STRUCTURE NOTES

POR-76-9.735, POR-76-9.895, POR-76-10.072, POR-76-11.143, POR-76-11.266R
POR-76-11.267L, POR-76-13.060L, POR-76-13.076R, POR-76-14.894, POR-76-16.106

PROJECT ID
112778

ITEM 516 - STRUCTURAL EXPANSION JOINT INCLUDING ELASTOMERIC STRIP SEAL, AS PER PLAN

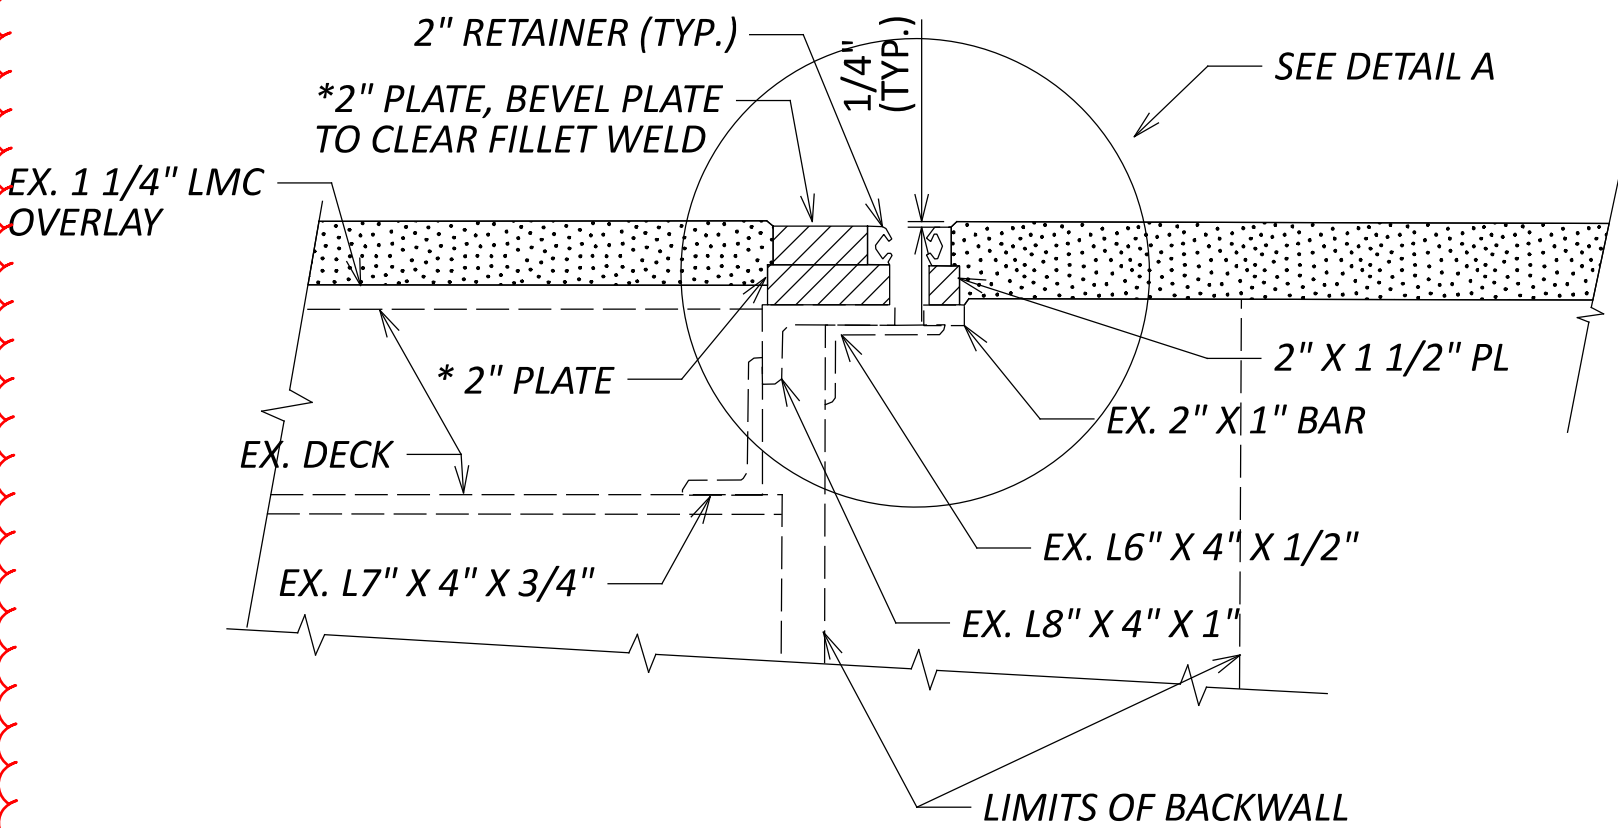
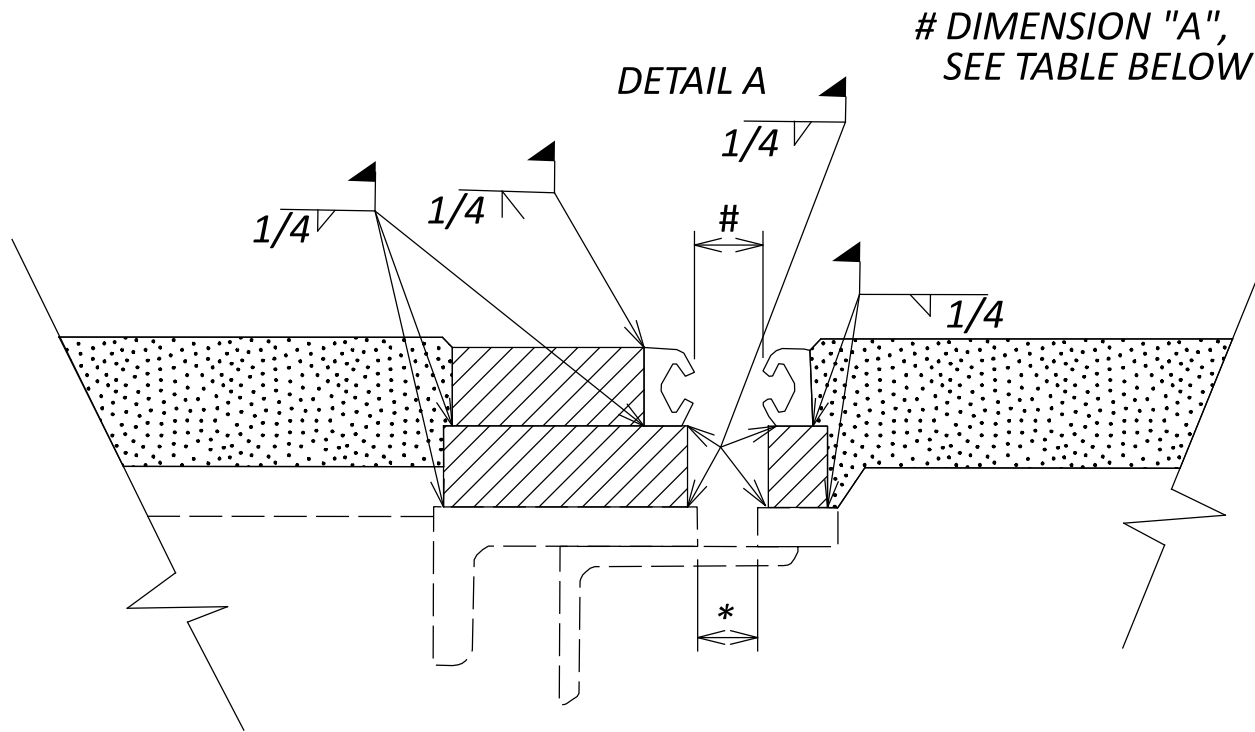
THIS ITEM OF WORK CONSISTS OF REMOVING AND INSTALLING NEW ELASTOMERIC STRIP SEALS, RETAINERS, PLATES, AND ALL OTHER COMPONENTS FOR STRUCTURES POR-76-11.266R AND POR-76-11.267L AS DETAILED BELOW. ALL WORK, LABOR, MATERIALS, AND EQUIPMENT NEEDED TO PERFORM THIS WORK SHALL BE PAID FOR UNDER THE UNIT BID PRICE FOR ITEM 516 - STRUCTURAL EXPANSION JOINT INCLUDING ELASTOMERIC STRIP SEAL, AS PER PLAN.

* CONTRACTOR TO DETERMINE EXACT WIDTH IN THE FIELD AND GET APPROVAL FROM THE PROJECT ENGINEER PRIOR TO INSTALLATION

added note, moved other notes around
